STORM SEWER IMPROVEMENTS

to serve
Wendys 601 N West Street.

2022 - 000756 PPD

AS BUILTS

Wendys 601 N West St.
SWS Plan and Profile - Line 1
Wichita, Kansas

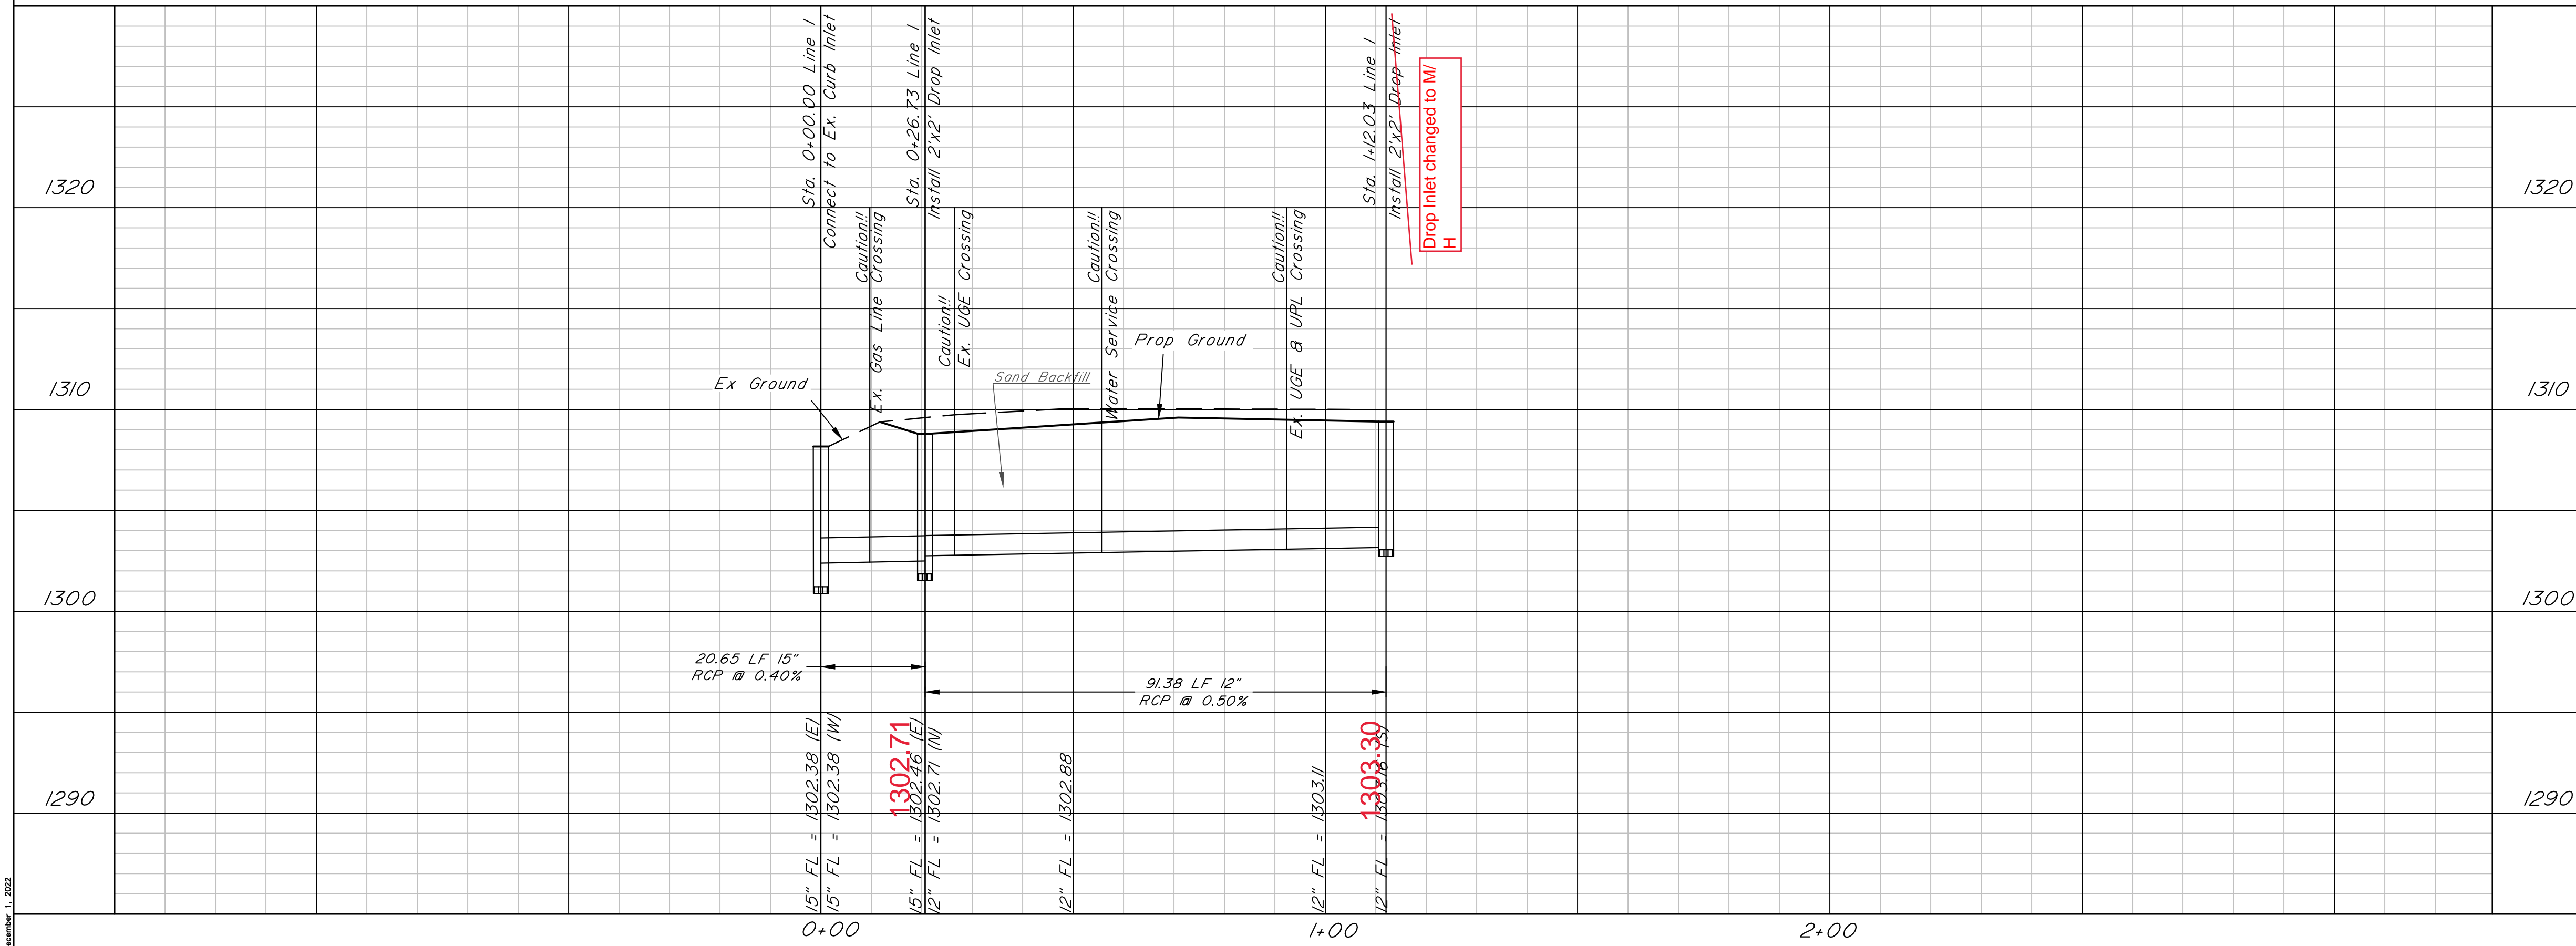
2'X2' Drop inlet was changed to a
Manhole with area inlet
